From: Mark Seel
To: Kleinberg, Sam; pandersonpe@gmail.com
Cc: MacNeill, Ryan; Rizzo, Jordan; Hernández, Nelson; Mazier, Alejandra
Subject: RE: WEHI
Date: Tuesday, December 9, 2025 4:52:02 PM
Attachments: Ref Miao 2025.pdf
Ref Stevens 2006.pdf

SURFICIAL SLOPE STABILITY

Project: WEHI
Location: Cross Section A

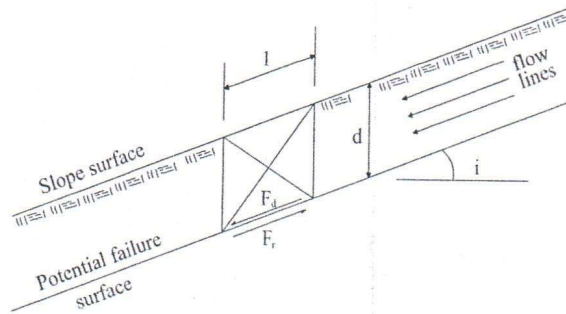
1. A basis or reference should be provided for the selection of $c=100$ psf . For example see attached ref from "Biotechnical Slope Protection and Erosion Control" The values selected should be based on a representative estimate of the root area ratio. *The use of RAR is considered a specialized analytical technique not a universal standard of practice in typical New Jersey geotechnical engineering design. You'll recall that Langan evaluated a higher water table, which in our opinion was a worst-case condition considering there is no groundwater, and the design case you've asked us to consider seems unlikely as you testified to last week that this analysis represents a condition that is extraordinarily unlikely to occur or be problematic. The references on the subject typically relate to tree species and steep slopes in the western US/Canada/Mexico and overseas in China, New Zealand, etc. where steep slopes are generally more susceptible to failure, not specifically to conditions in the eastern US. The slopes east of Building D are generally not steep. References are attached. Miao, et al 2025 indicates trees at least 20 feet in height and 30 years of age have at least 7.5 kPa (156 psf) apparent root cohesion, and larger older trees upwards of 10 kPa (208 psf). Stevens, et al, 2006 indicates natural forests and lab analysis have apparent root cohesion of at least 25 kPa (522 psf) and 4.9 kPa (100 psf), respectively. The site has a very mature older growth woodland setting. Based on these technical references, an effective root cohesion of more than 150 psf is substantiated. See our response to #3 below for more discussion.*

1. A basis or reference should be provided for the selection of $c=100$ psf . For example see attached ref from "Biotechnical Slope Protection and Erosion Control" The values selected should be based on a representative estimate of the root area ratio.
2. The FS decreases quickly with depth. The analysis should, in our opinion be extended to at least 3 feet depth.
3. Based on our initial review safety factors of 1.2 would be appropriate for an extreme event.

FS for Critical Slope Ratio (horiz.:vert.)
Depth, d (ft.)	2.85H:1V
0.5	6.32
1	3.54
2	2.14
